Thank you for your invitation for submissions regarding DA20/0109 for the construction of 2 x 2 storey units at the rear of 51 Simmons Street.

Re: DA20/0109 – 51 Simmons Street, Wagga Wagga NSW

View in laneway looking eastward.

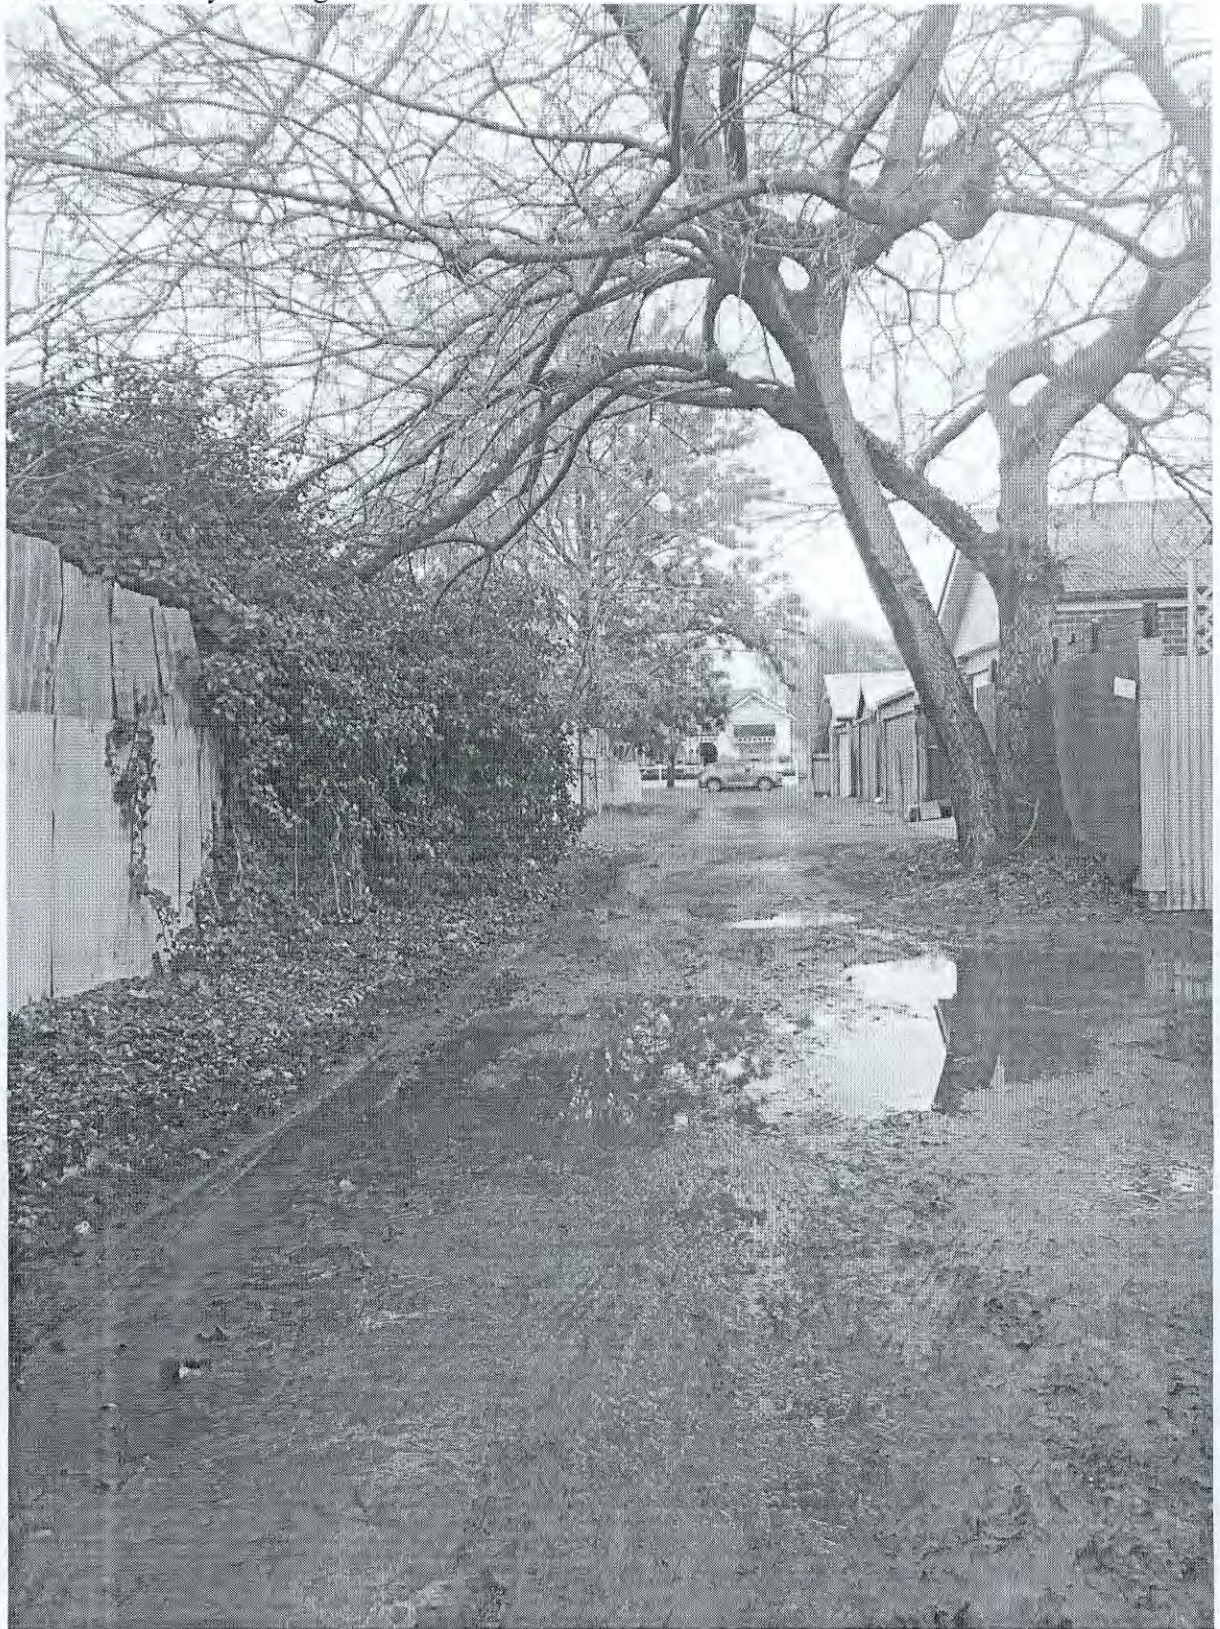
- The service laneway has a deteriorated, unsealed surface and there is no existing kerbing or guttering.
- The laneway surface has many depressions and low spots and no drainage infrastructure or cross falls to drain surface water.
